**No or intermittent unlocking function from door handles
(S60 w/ Keyless drive)**

REF NO: TJ 26520	ISSUING DEPARTMENT: Technical Service	CAR MARKET: United States and Canada		
PARTNER: 3 US 7510 Volvo Cars North America		ISSUE DATE:		
FUNC GROUP: 8340	FUNC DESC: Lock, handle	YEAR 2013	MONTH 01	DAY 09
Page 1 of 4

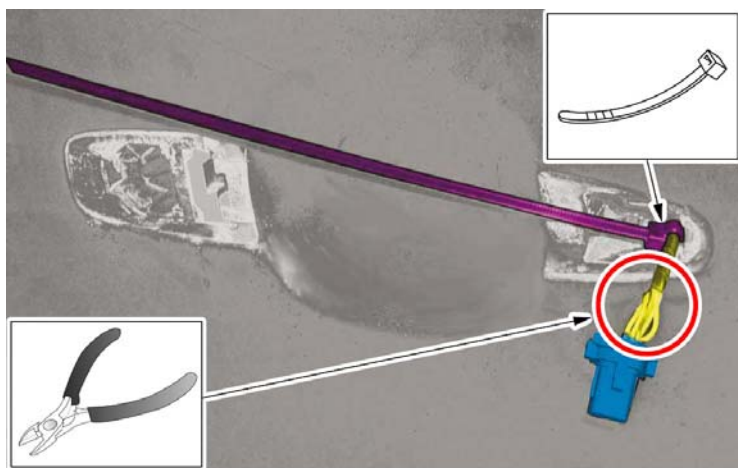
No or intermittent unlocking function from door handles on S60 vehicles with Keyless drive may be caused by low pin tension at the harness connector.

Replace the connector on the affected door(s) according to the attachment with extension cables:

- Front door: 31358682
- Rear door: 31382553

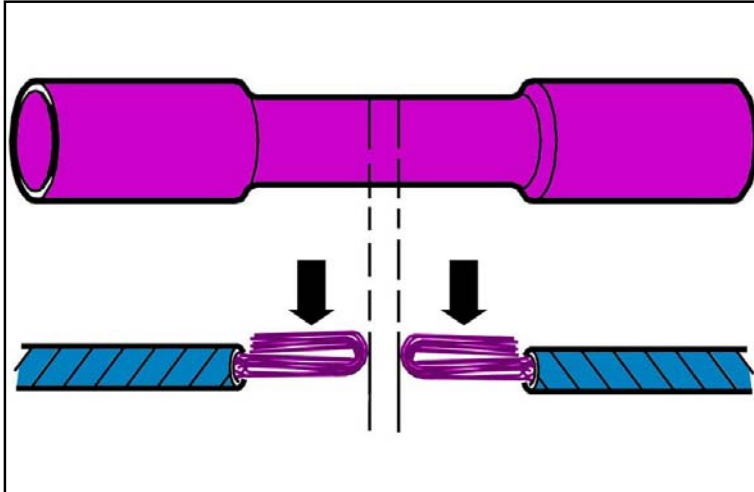
Cut off the existing connector.

1: Front Door

2: Rear Door

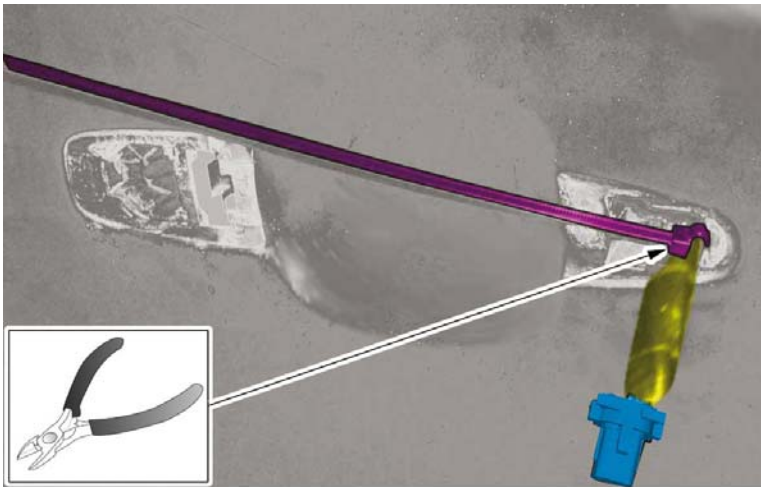
Cut the wiring length of the extension cable to correctly match the vehicle.

Splice the wires as shown.

Complete the splices according to VIDA Repair->Cleaning, Inspection and Adjustment->371 Joining Cables
